Gunns Pulp Mill Approval EPBC 2007/3385 - Schedule 1 Maps

Proposed changes overlaid onto existing Schedule 1 maps

Bell Bay Pulpmill: Location Map

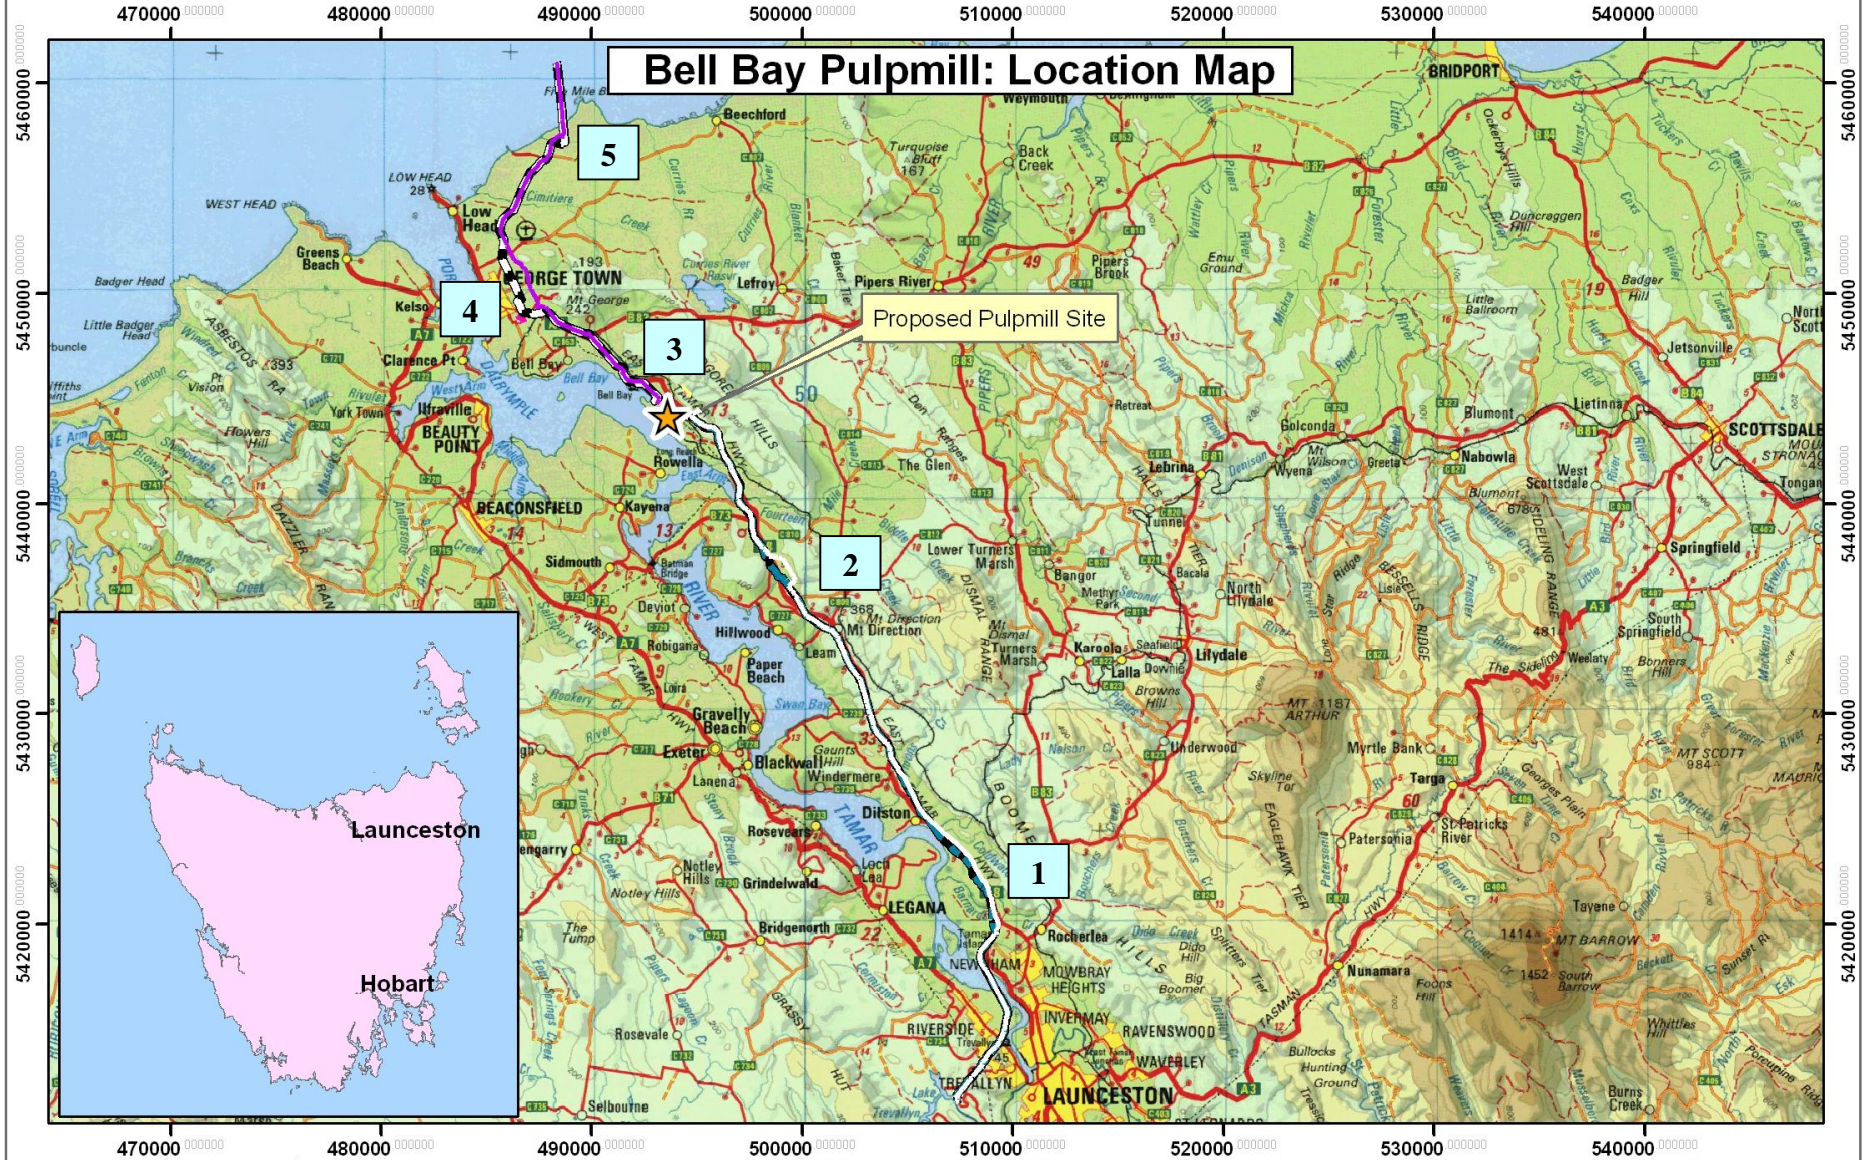
Proposed revised pipeline corridors (white for water pipeline, purple for effluent pipeline) overlaid onto an existing Schedule 1 map. The proposed deviations from the existing Schedule 1 corridor are identified by number – see Attachment 2 for reasons for the proposed deviations.

Name	Reason for new alignment
1. Dilston Bypass	Subsequent to the approval the new State and Commonwealth funded Dilston bypass project has commenced. The Dilston Bypass will create an additional linear corridor across private land. At the request of landowners, the pipeline corridor has therefore been adjusted to run adjacent to the bypass corridor, effectively consolidating the two corridors into one to reduce impacts on landowners.

2. Egg Island Creek	Westwood Holdings have not agreed to the pipeline corridor running through their land in the vicinity of the landowner's residence. The corridor adjustment deviates around this property on a property owned by Gunns.

3. Bell Bay power station	Subsequent to the approval the Alinta power station has been constructed over the route alignment. The proposed corridor deviates around the power station. The deviation creates additional constraints due to a pinch point of multiple services that must be avoided.

4. George Town	<p>After earlier agreement with the George Town Council on the original pipeline corridor through George Town, Council now require the corridor to follow a new alignment further to the east of the town so as not to impede town development.</p> <p>Of all the deviations, this is the only one for which two options need to be provided for. George Town Council has nominated the deviation as its preferred route. This option is being negotiated with the landowners and Council is assisting with these negotiations.</p>

5. Shore crossing	<p>In the original corridor, the Basslink high voltage cable was to be crossed by tunnelling under it. With the tunnelling method, the pipeline stringing operation would have been conducted from a combined weight coating and pipe stringing yard inland of that dune. The pipeline would have been pulled through the tunnel as it was towed out to sea.</p> <p>Subsequent to the approval the owners Basslink require an above ground-crossing of Basslink. The sharp change in vertical alignment prevents the achievement of a straight line pipeline pull from inland of the dune, which means that the stringing yard now needs to be seaward of Basslink.</p> <p>This relocation of the stringing yard separates it from the weight coating yard, which can now be relocated to a more convenient area, adjacent to Aerodrome Road. The change also allows the pipeline alignment from the stringing yard to the relocated weight coating yard to be modified to achieve a lower environmental impact.</p> <p>The net result of these changes is a proposed new construction corridor.</p>

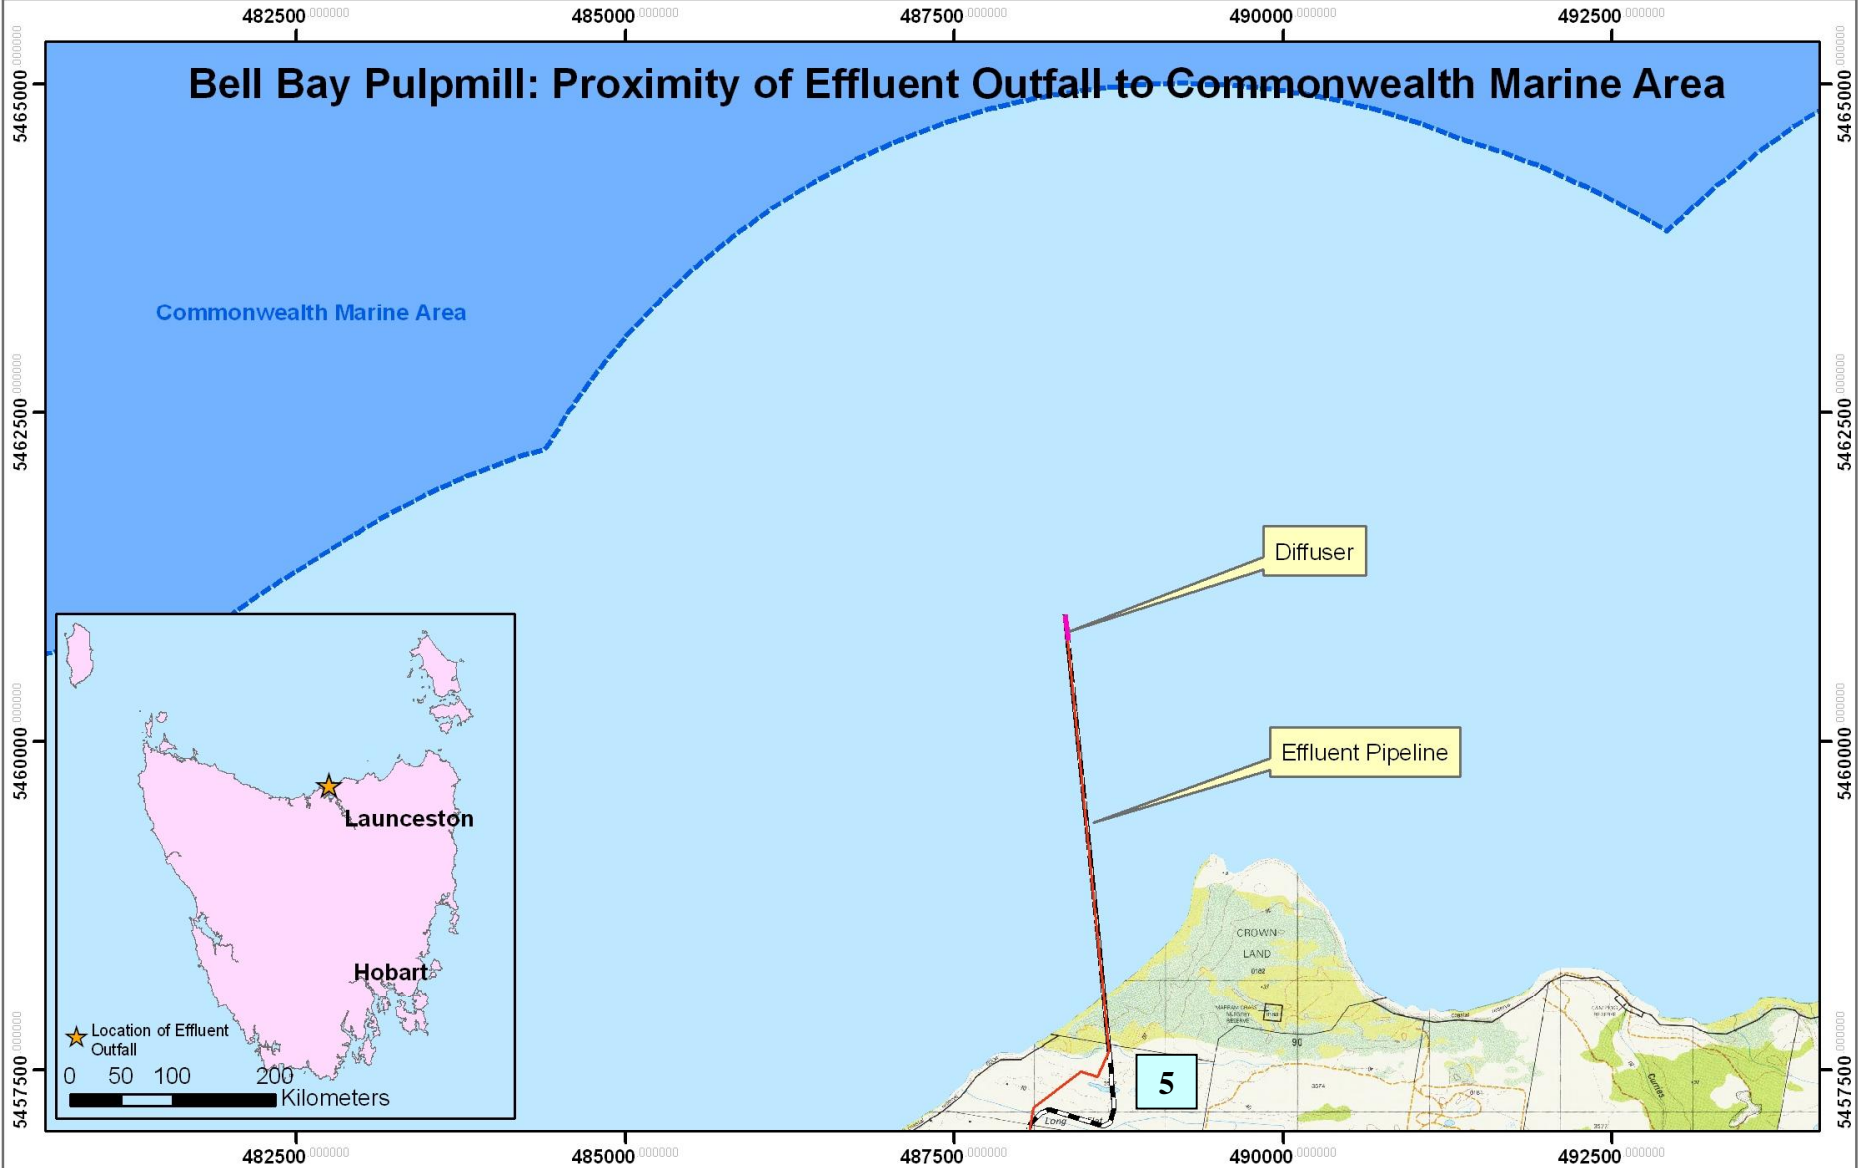
Proposed revised pipeline corridors (yellow dotted for water pipeline, black dotted for effluent pipeline) overlaid onto an existing Schedule 1 map. The proposed deviations from the existing Schedule 1 corridor are identified by number – see Attachment 2 for reasons for the proposed deviations.

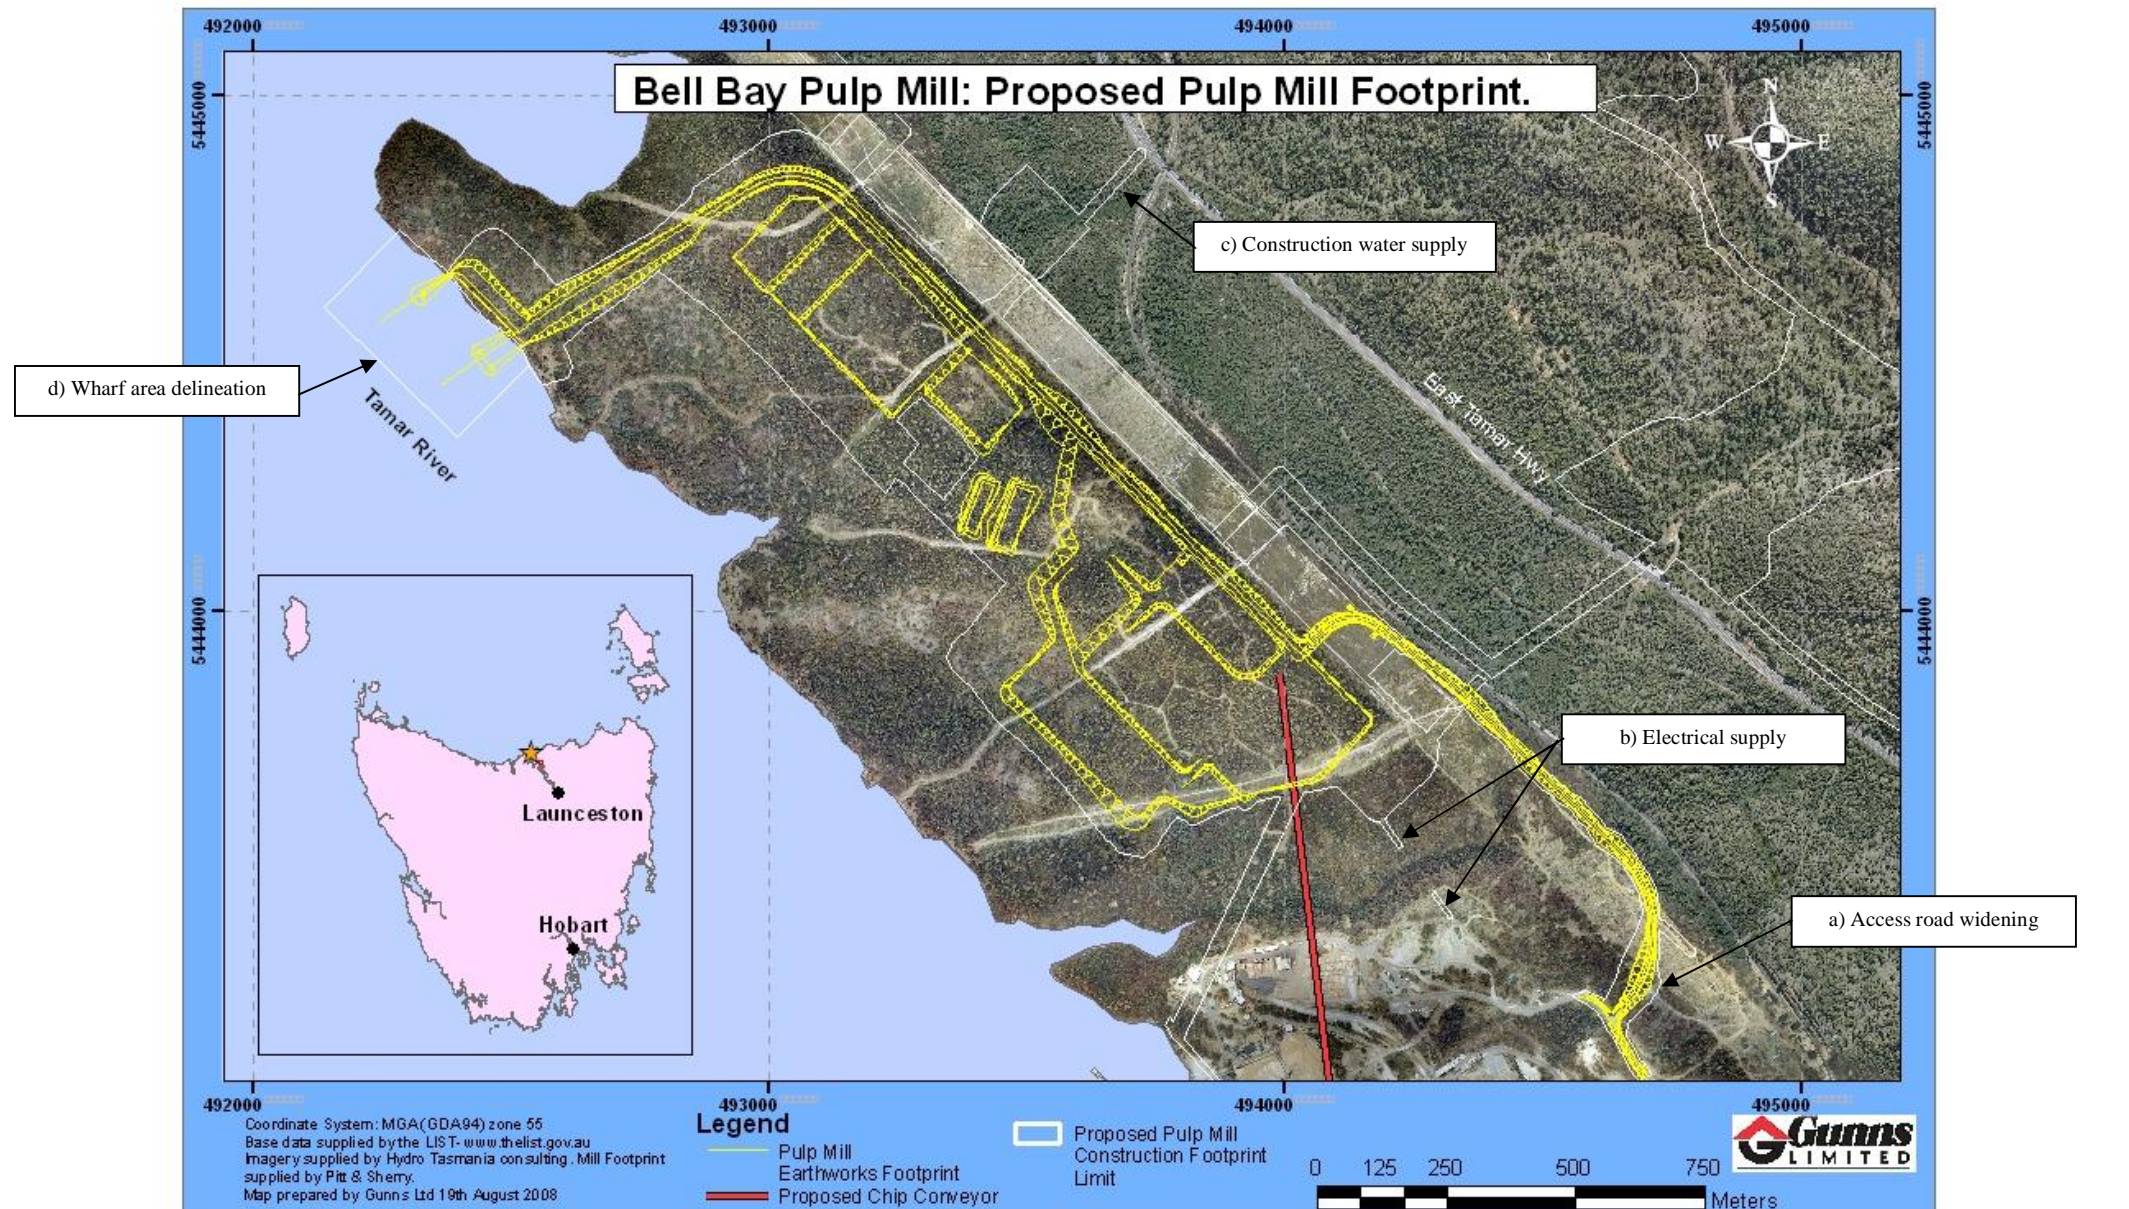
Proposed revised effluent pipeline corridor (red) overlaid onto an existing Schedule 1 map. The proposed deviation from the existing Schedule 1 corridor is identified by number – see Attachment 2 for reasons for the proposed deviation.

Bell Bay Pulp Mill: Pulp Mill Project Construction Footprint.

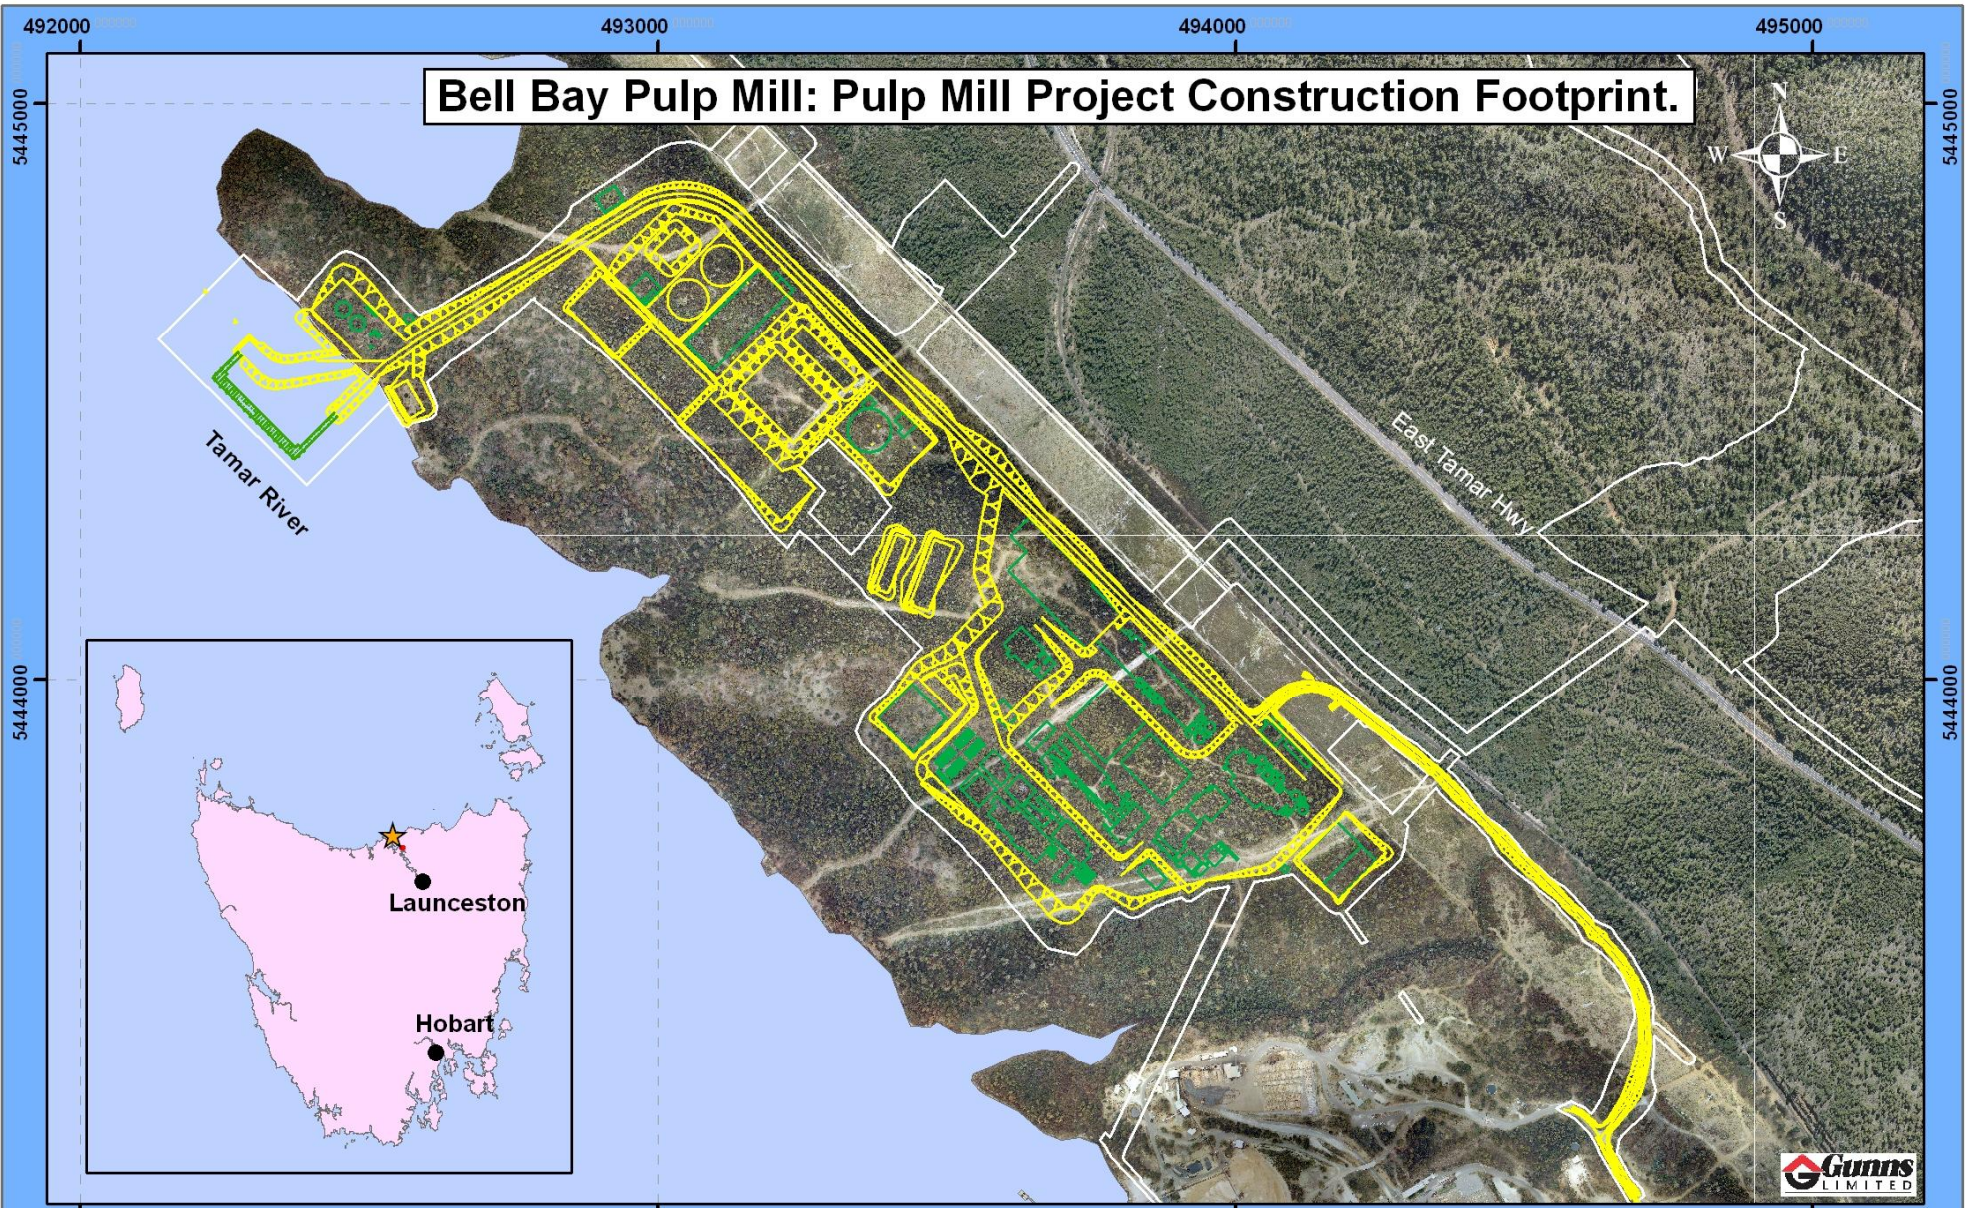
There have also been some minor changes to the pulp mill footprint relative to that shown in the Schedule 1 maps. For example, the shape of the wharf groynes has changed and we are now proposing to construct a gatehouse on the access road as part of the agreed roadkill management measures. Your Department has advised that these changes should also be provided for by replacing the pulp mill footprint map in Schedule 1 with an updated map.

Proposed project area construction footprint limit (white line) overlaid onto the bulk earthworks footprint (yellow) that is shown in the existing Schedule 1. Note that the corresponding map in Schedule 1 only shows the bulk earthworks footprint and not the project area footprint. The footprint limit shown above (white line) encompasses all elements of the project that are within the frame of this map (not just bulk earthworks). The footprint limit shown (white line) in this figure is consistent with the limits of the pulp mill impact footprint that were shown in Attachment 3 of the Preliminary Documentation and also in the approved EIMP modules apart from at the locations annotated on the figure: a) A widening of a section of the access road for the relocation of a Telstra cable and a water supply pipe to the chip mill and the siting of a vehicle washdown bay; b) The provision of a new electrical supply; c) The provision of a new construction water supply; and d) The rectangular delineation of the wharf area to encompass the whole wharf not just the groynes (note that the shape of the groynes themselves has changed from that shown in this figure also). The area of native vegetation impacted by these changes is included in the revised ~195 ha overall area of native vegetation that will be cleared, a reduction from the ~200 ha expected in the Preliminary Documentation.
